SITE PLAN: LOTS 308-309, PHASE 3B, THE PARKE AT OCEAN PINES, SECTION 16 OF OCEAN PINES, THIRD TAX DISTRICT, WORCESTER COUNTY, MARYLAND

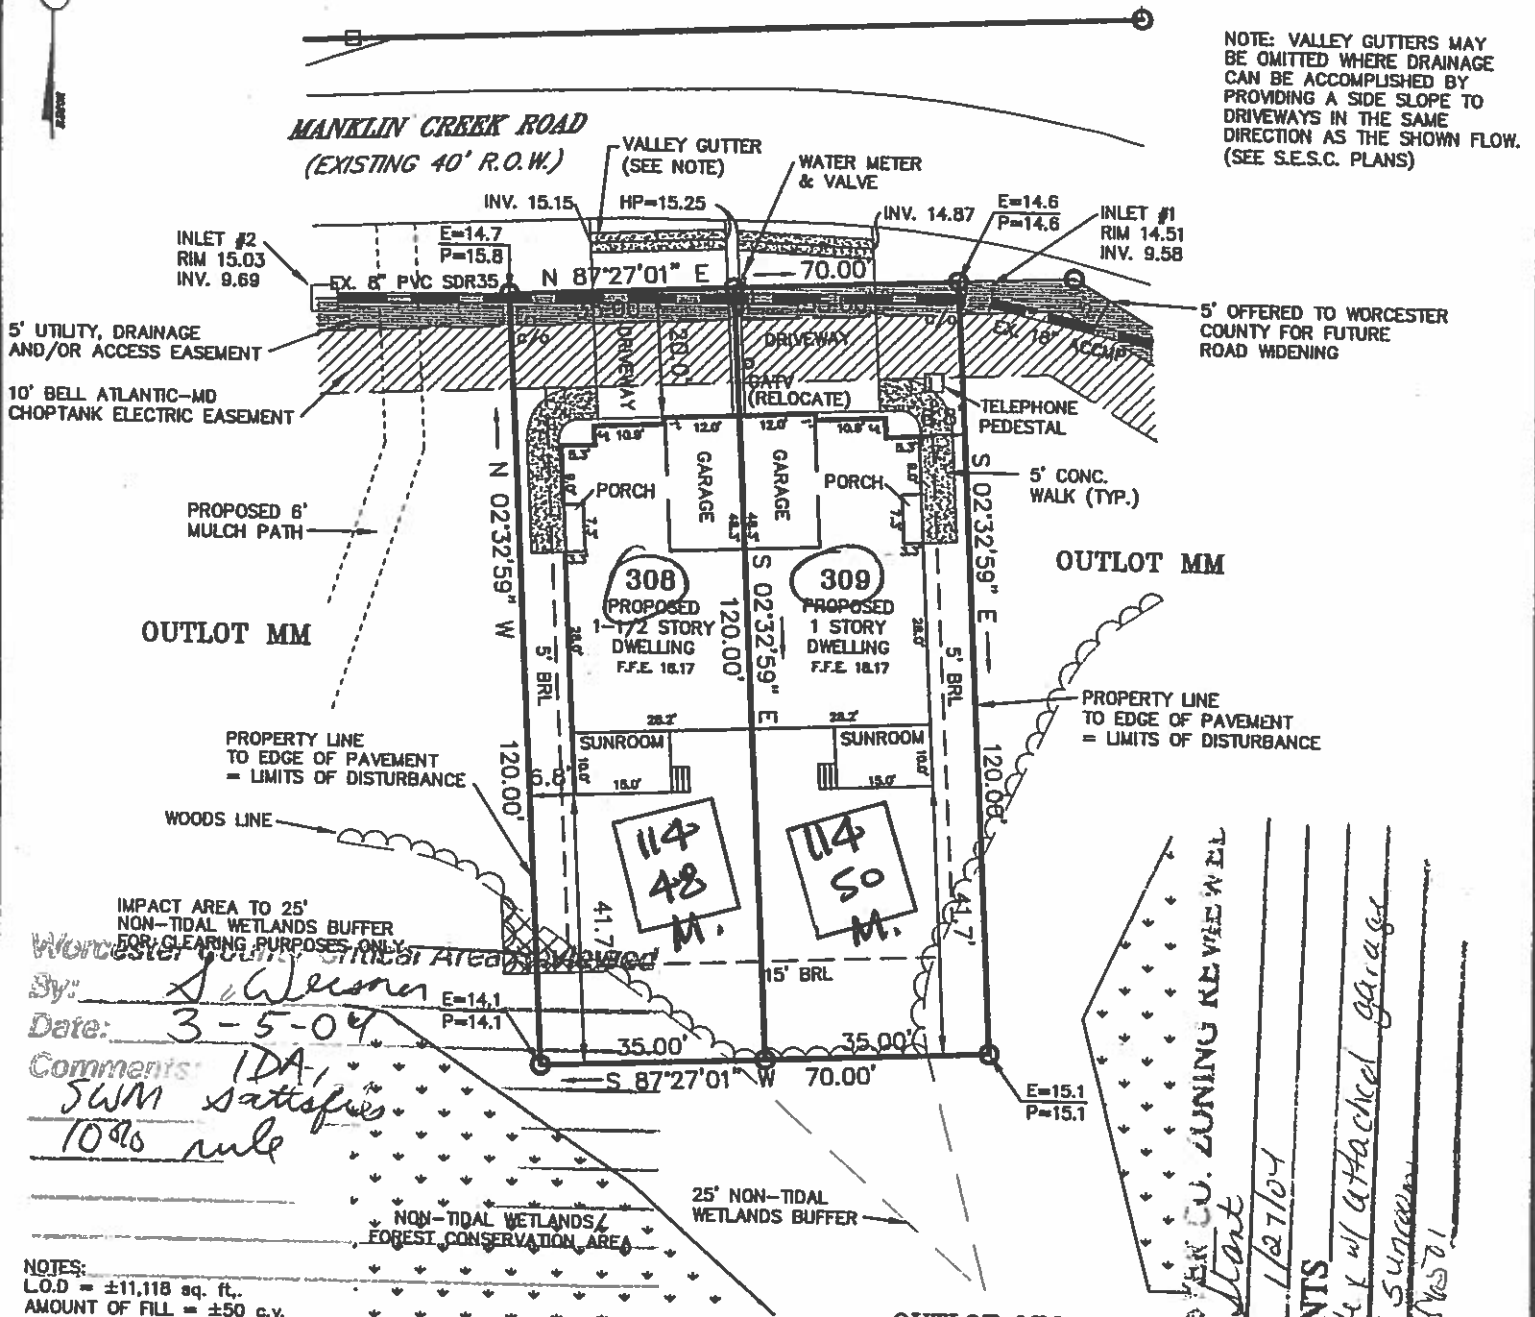
By: *S. Wilson*
Date: *3-5-04*
Comments: *IDA, SWM satisfies 10% rule*

DATE: *1/27/04*
COMMENTS: *Dupl. w/ attached garage plan. Sunroom. P.P. 1/27/04*
